Stage 3 - Acoustic Design Review

**New Skills Centre, ELRS
Port Talbot**

7597/ADR1_Stage 3_Preliminary

Project:	New Skills Centre, ELRS
Site Address:	Port Talbot SA13 1YY
HA Reference:	7597/ADR1_Stage 3_Preliminary
Date:	10/09/2025
Client:	Tilbury Douglas 138 Heol-y-Gors Cwmbwrla Swansea SA5 8LT
Contact:	Matthew.Williams2@tilburydouglas.co.uk

Figure 4.1 External Construction Skills, Plastering and ASHP Compound

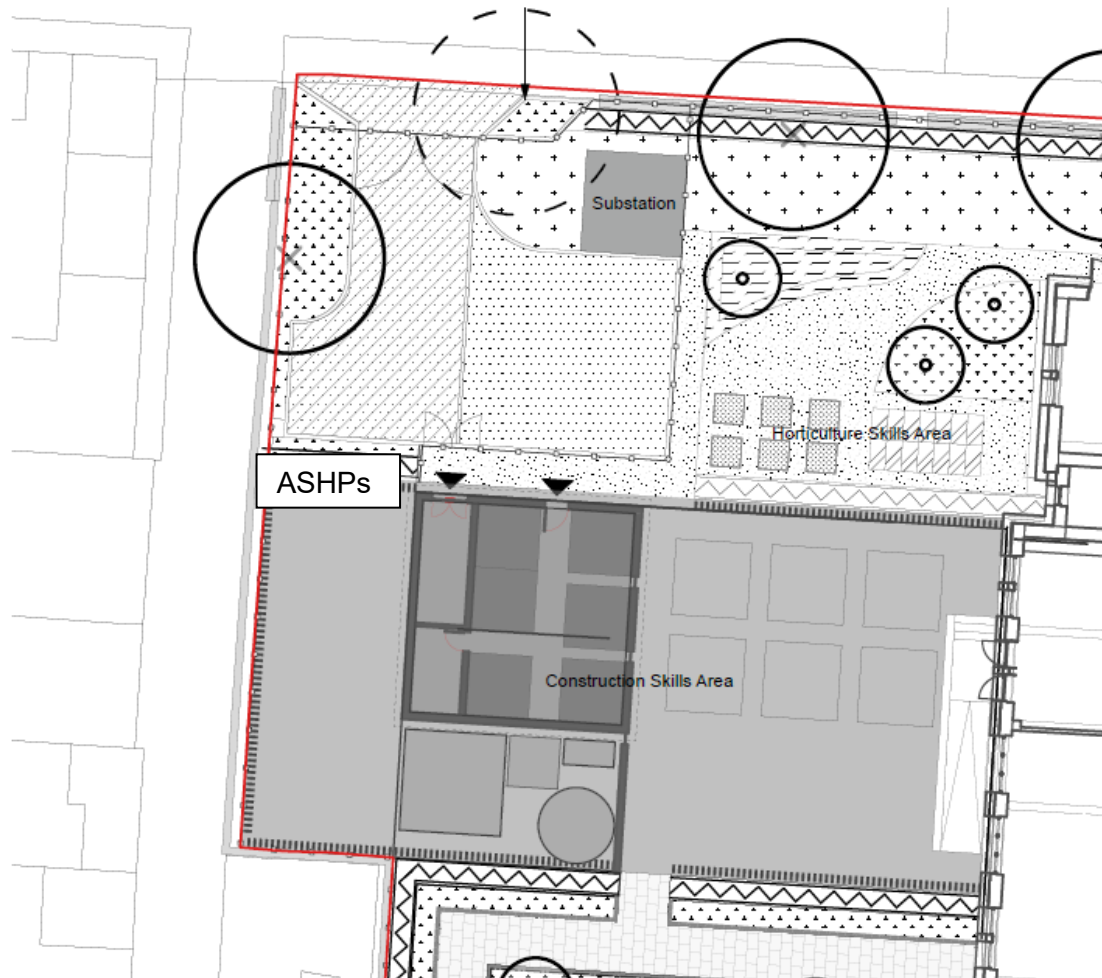
A new external workshop building (semi-enclosed) is to be used for plastering and tiling, with the Outdoor Construction Zone to be used for bricklaying and carpentry. The Client has advised there are to be no noisy power tools or activities. Noisy activities from power tools in the external areas should be avoided in order to minimise the impact on nearby residents.

Each of these activities could still produce adverse noise impacts at the residents which are in the immediate vicinity if carried out for significant periods during the day. External activities may also affect users in Creative Media rooms overlooking the area.

It is understood that ASHPs are to be located in an external compound on the western site boundary, 5-10m from the closest residences. Total ASHP noise levels should not exceed the plant rating noise levels quoted above.

6no Mitsubishi CAVH-R450YA-HPB units are proposed at this stage, quoted at 64dB(A) @1m.

A noise management strategy should be developed by the Client to ensure noise from external activities is minimised. This could include mixing cement and mortar indoors – however this is typically a short process (≈5mins?) so if it is done infrequently, this should reduce the impact.

Quiet methods of wall deconstruction, tile and plaster removal should be utilised where this activity is required.

Power tools for carpentry including circular/bench saws, electric drills and screwdrivers, nail guns should be used indoors, with hand tools used only externally.

A minimum 2.5m high solid imperforate fence shall be included around the ASHP compound. The fence shall have a minimum mass per unit area of 10kg/m² for the lifetime of the product, and shall include an absorbent inner facing:

Figure B.2 - First Floor

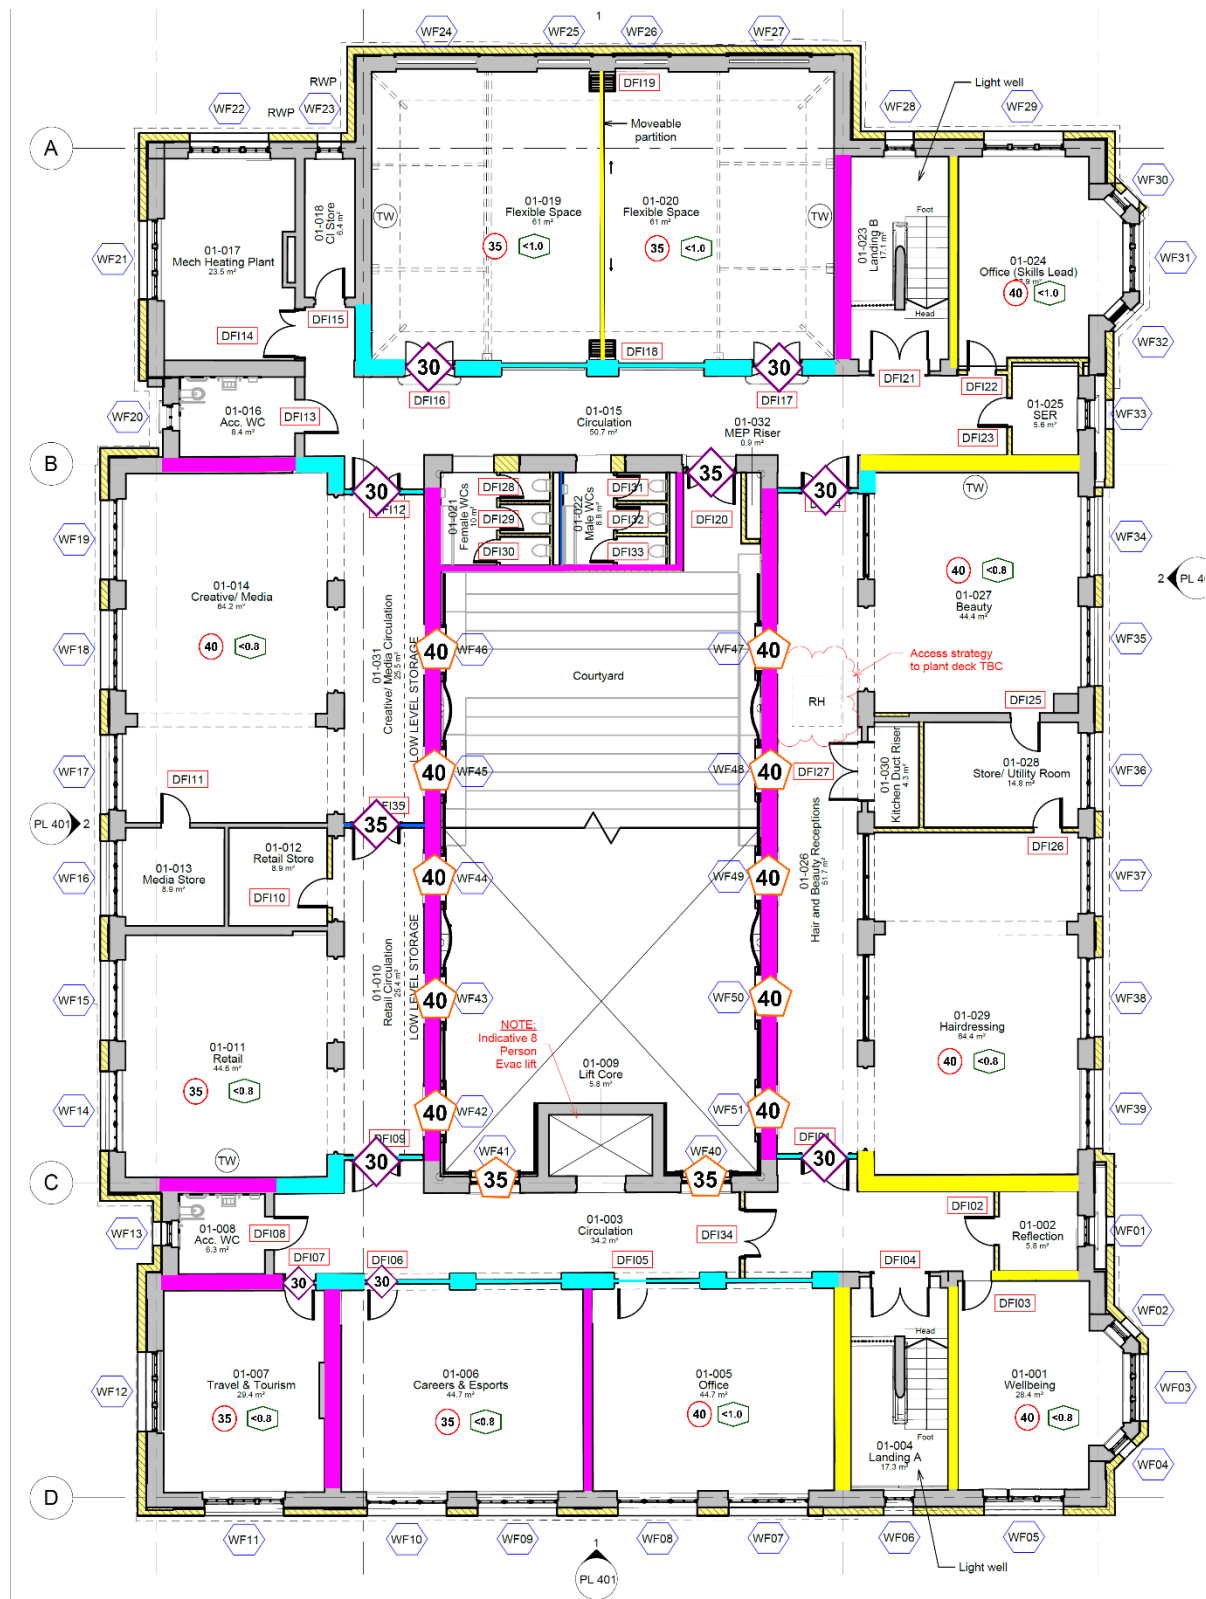
Figure B.1 and Figure B.2 show floor plans marked up with acoustic performance requirements, based on achieving new-build performance standards where indicated practicable.

Door performance requirements are shown on Figure B.1 and Figure B.2

Performance requirements for internal glazed screens are shown on Figure B.1 and Figure B.2.

Entrance doors to teaching/training areas to meet R_w30 , with upgraded R_w35 doors recommended to higher noise Engineering/Construction Zone.

Interconnecting door between Creative Media and Retail shall be $R_w 35$ dB.

Include R_w 40dB glazed screens between the Courtyard and to hairdressing/ beauty, Creative Media and Retail, Engineering, and Café.
